**BEFORE THE INDEPENDENT HEARING PANEL  
FOR THE QUEENSTOWN LAKES PROPOSED DISTRICT PLAN**

<b>Under the</b>	Resource Management Act 1991
<b>In the matter</b>	of the Urban Intensification Variation to the proposed Queenstown Lakes District Plan

**REBUTTAL EVIDENCE OF CORINNE FRISCHKNECHT  
ON BEHALF OF QUEENSTOWN LAKES DISTRICT COUNCIL**

**PLANNING: TEXT – Queenstown Town Centre, Local Shopping Centre, Medium Density  
Residential Zone, High Density Residential Zone**

Figure 3: UIV notified Height Precinct Map

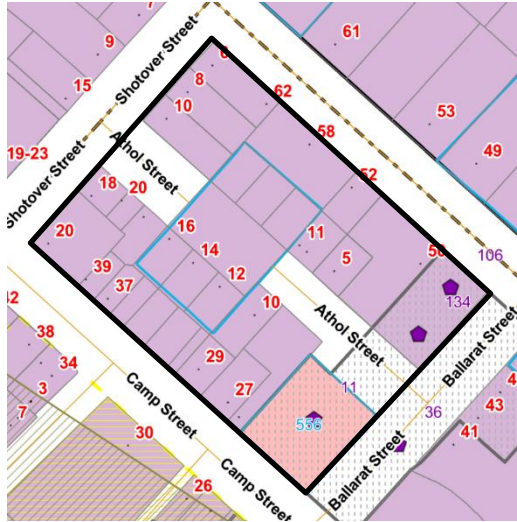
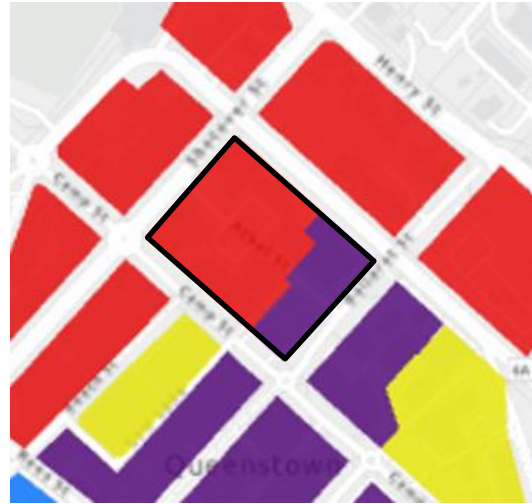
**4.29** A review of the notified Height Precinct Map has identified that three areas have been incorrectly included in Height Precinct 1 (8m height limit) as notified. These areas do not contain any developable land, and their inclusion appears to be a mapping error.

**4.30** None of these areas are associated with developable titles or anticipated built form, and applying a height limit is not meaningful or necessary.

**4.32** These are minor corrections to improve the accuracy and clarity of the planning maps. The changes do not alter the effect of the provisions, or the outcome intended by the variation, and therefore do not require a section 32AA evaluation.

Figure 4: Rebuttal recommended Precinct Plan

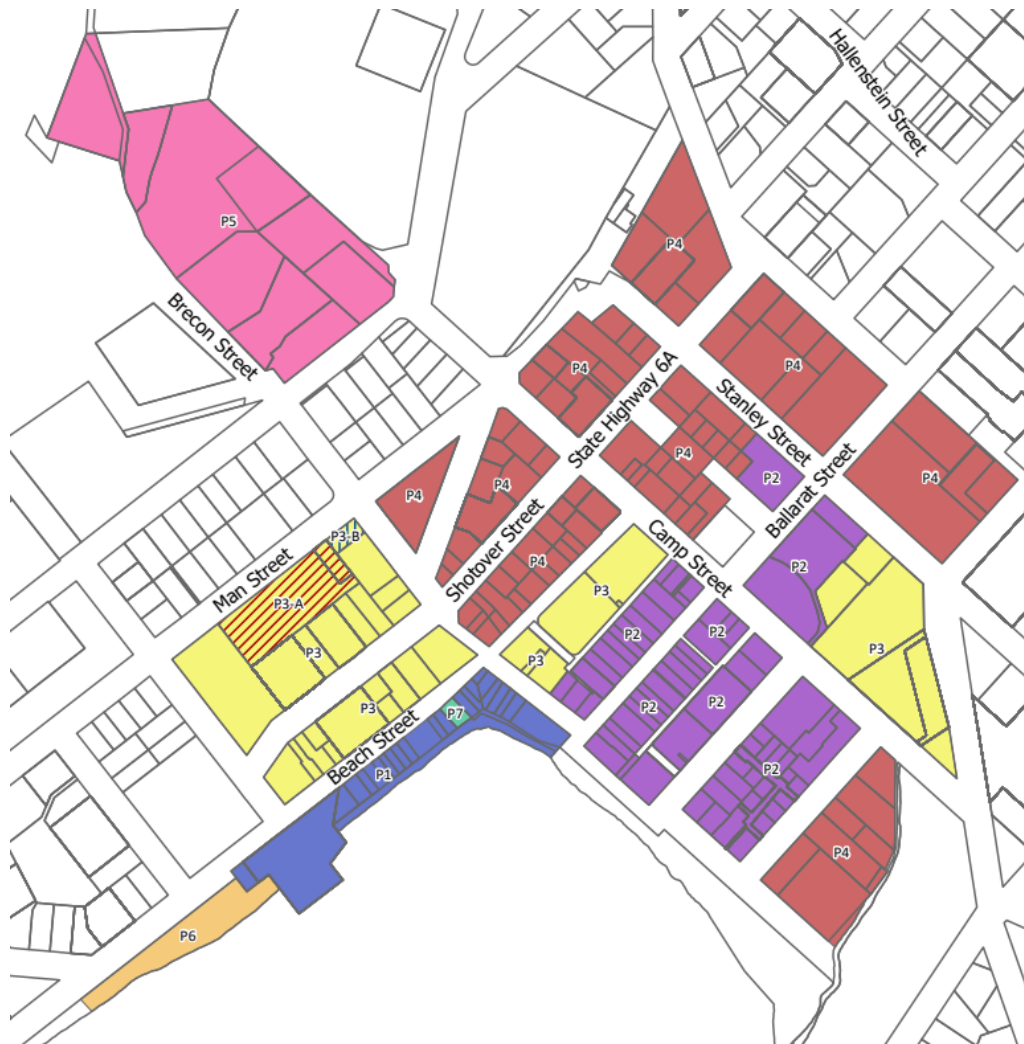
- (a) The Precinct Plan is updated to:
  - (i) Reclassify 2 and 22 Earl Street from Height Precinct 3 to Height Precinct 4; and
  - (ii) Reclassify 11-15, 17 and 19 Rees Street from Height Precinct 2 to Height Precinct 3; and

- (iii) Create a new Height Precinct (7) for 48 – 50 Beach Street as shown below:

- (b) Rule 12.5.9 is updated to apply a height limit of 15m for Height Precinct 7 as follows (changes in blue):

Figure 6: S42A recommended Precinct Plan with identified Areas A and B

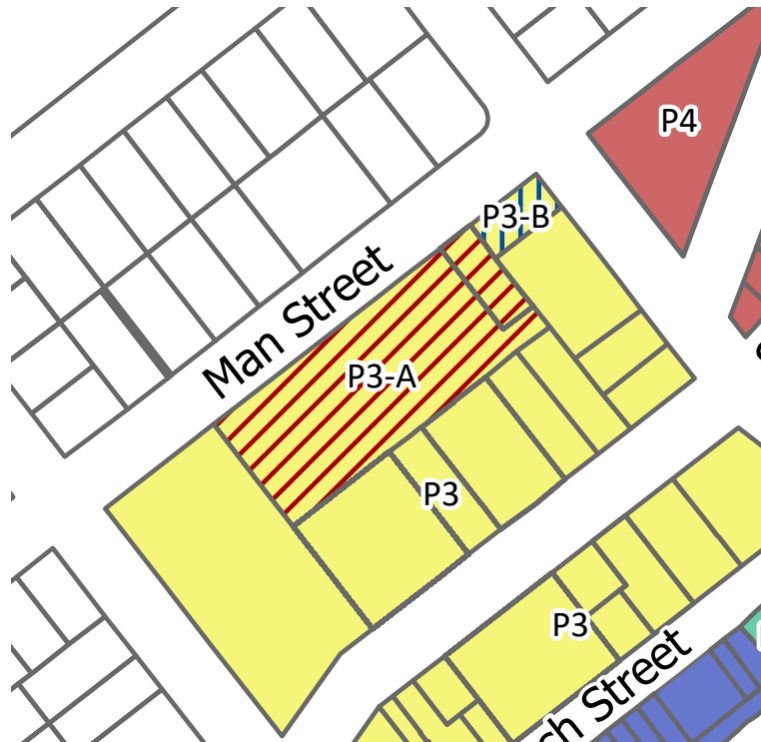
- 4.40** When considering the relief sought, I acknowledge that existing Rule 12.5.9.1(d) (which is proposed to be deleted in the notified provisions) provides bespoke height provisions where the building height is measured from a fixed datum point. This responds to the topography of Height Precinct 7 (Man Street) as identified in the existing Height Precinct Plan as well as the location of the site which has two frontages, which in turn means two high level building setbacks. When assessing the built form that can be achieved on the site with the notified version, against the relief that the submitter is seeking, in my view, the outcomes are similar, and would still align with the PDP objectives, particularly PDP SO 3.2.3 and SO's 3.2.3.1, 3.2.3.2 and 3.2.3.2 in that the relief sought integrated with its surrounding urban environment by retaining the overall amphitheatre approach.

- xvi. In Height Precinct 3 (Man Street), in Area A shown on the Height Precinct Map, the maximum height shall be 20m, above RL 327.1 masl
- xvii. In Height Precinct 3 (Man Street), in Area B shown on the Height Precinct Map, the maximum height shall be 20m, above RL 326.5 masl
